ADDENDUM NO. 1

Project Name: Moorhen Marsh Low Energy Aquatic Plant System

Bid Number: 2020030

This addendum is being released to extend the deadline for receipt of bids to July 14, 2020, to modify bid documents, to answer questions received to date, and to provide details of a scheduled site visit.

SITE GRADING WITHOUT EXISTING TOPOGRAPHY
PROJECT NO. 3/10/2020
SCALE 1"=40'
SHEET C2b

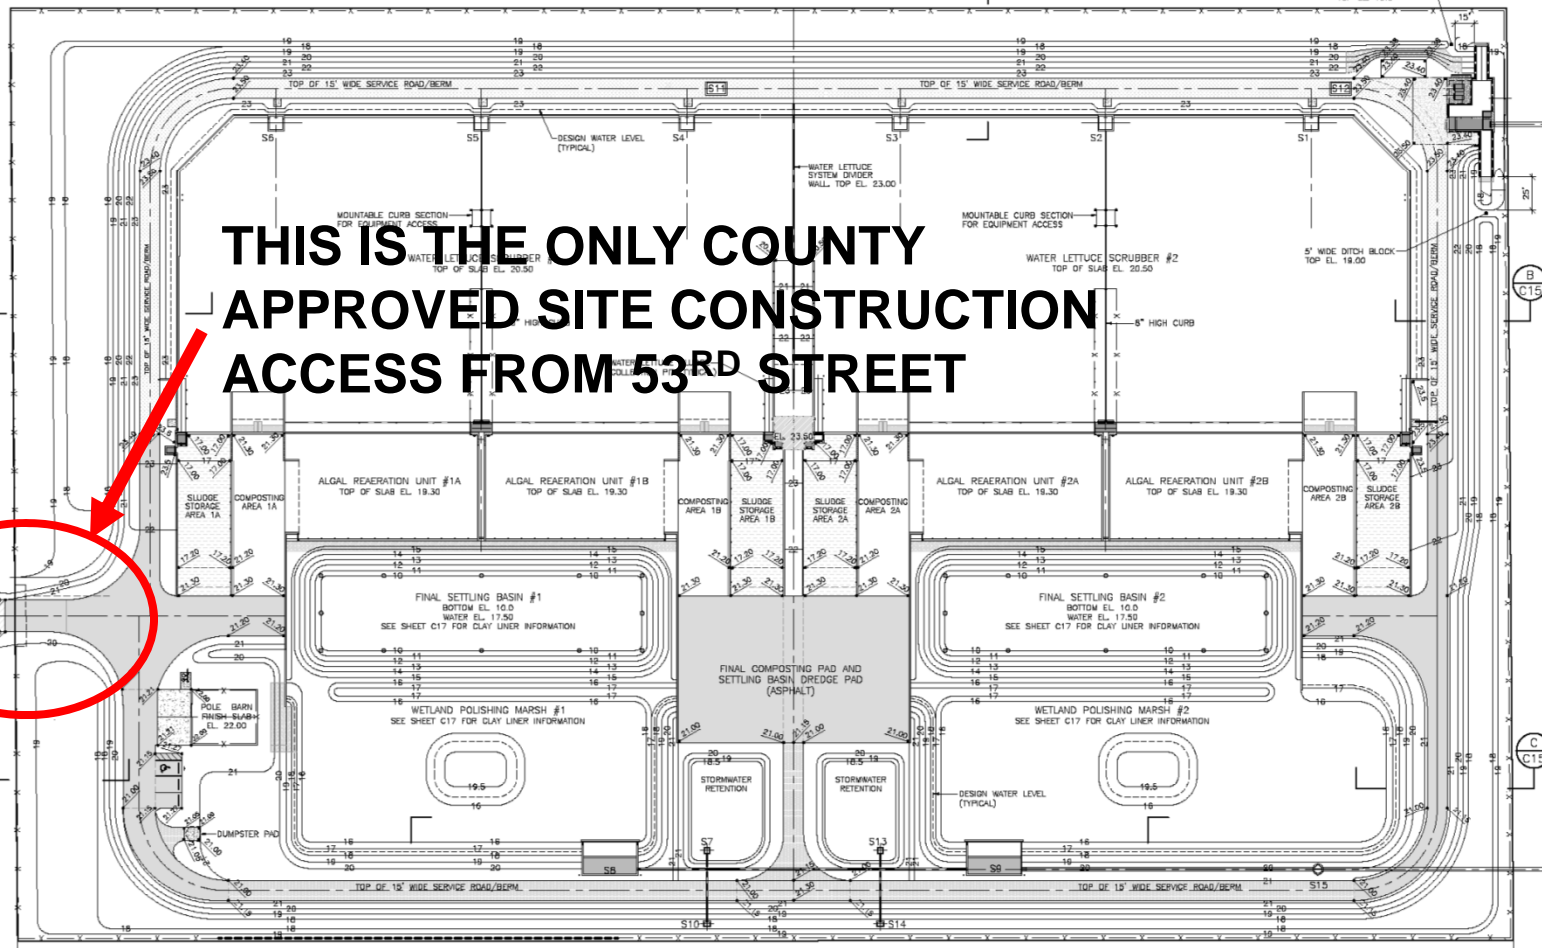
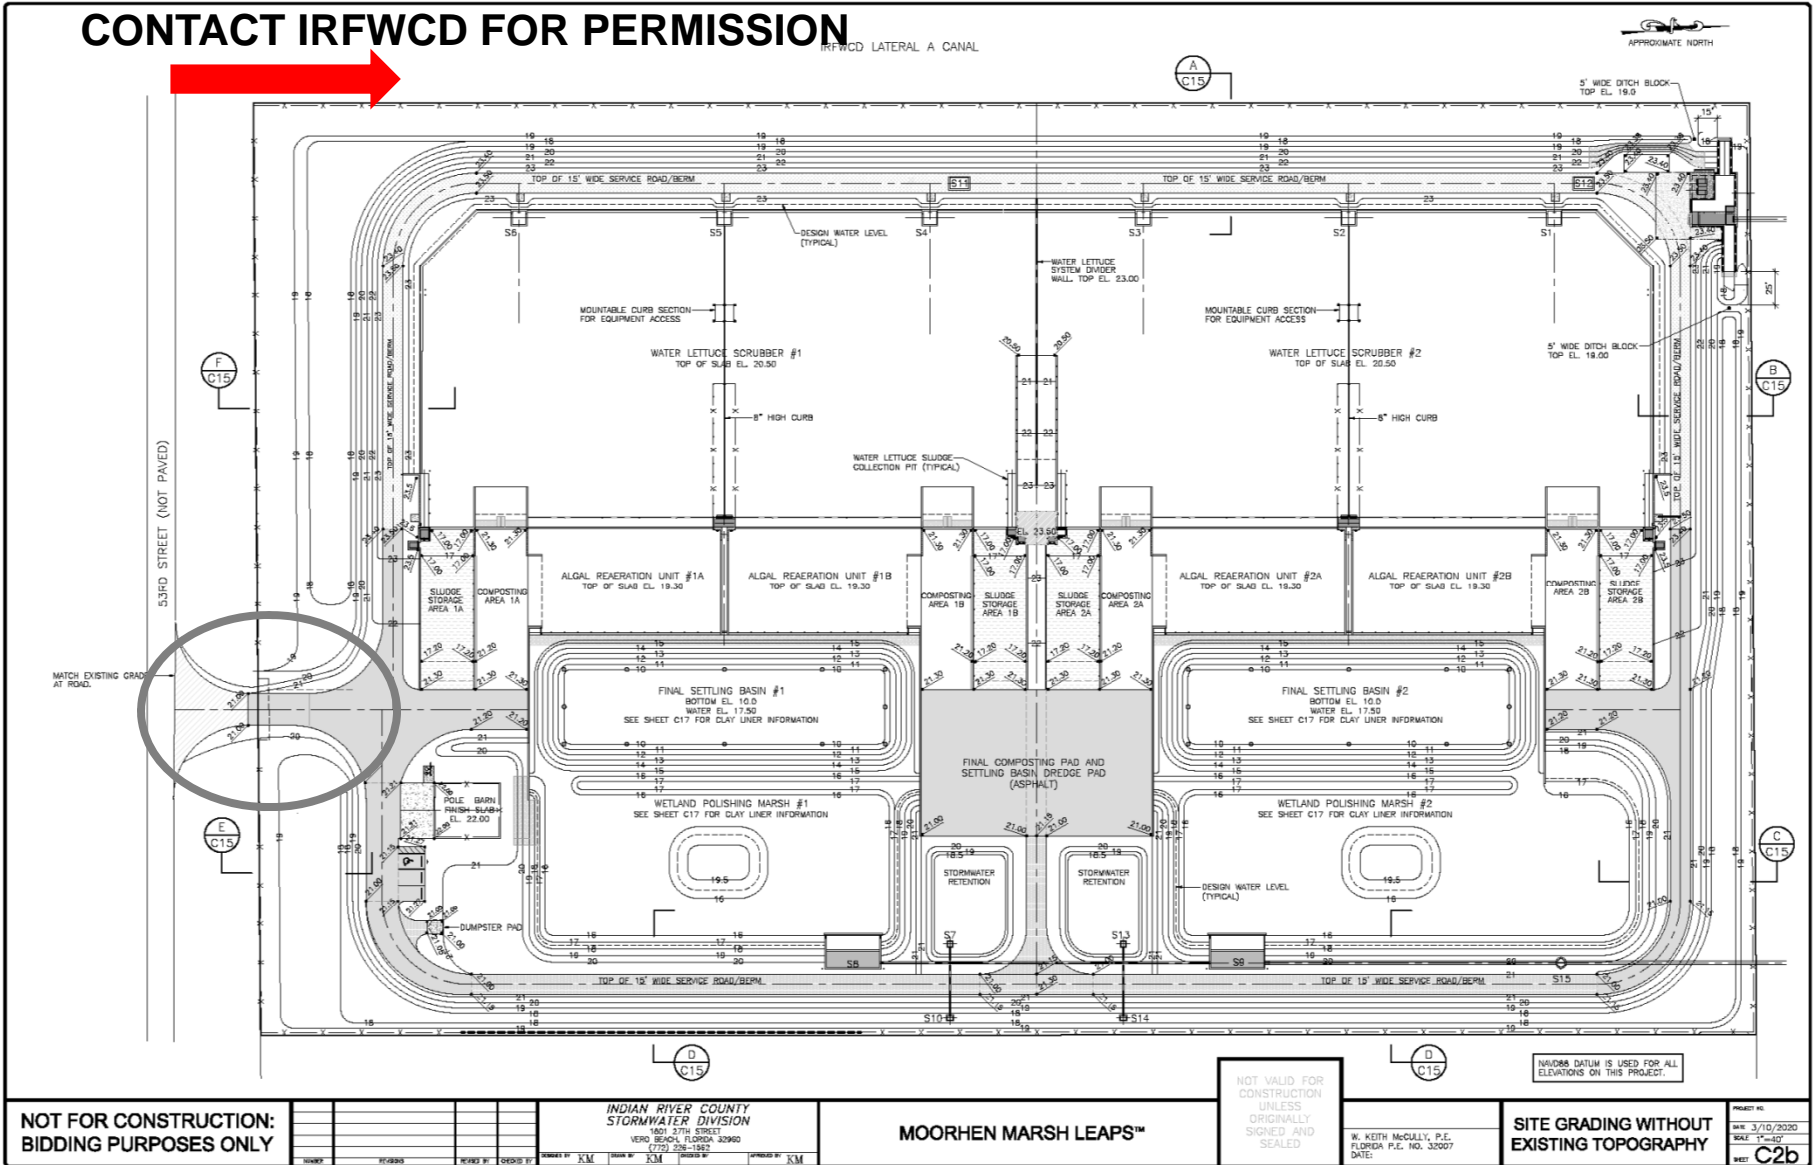
**THIS IS THE ONLY COUNTY
APPROVED SITE CONSTRUCTION
ACCESS FROM 53RD STREET**
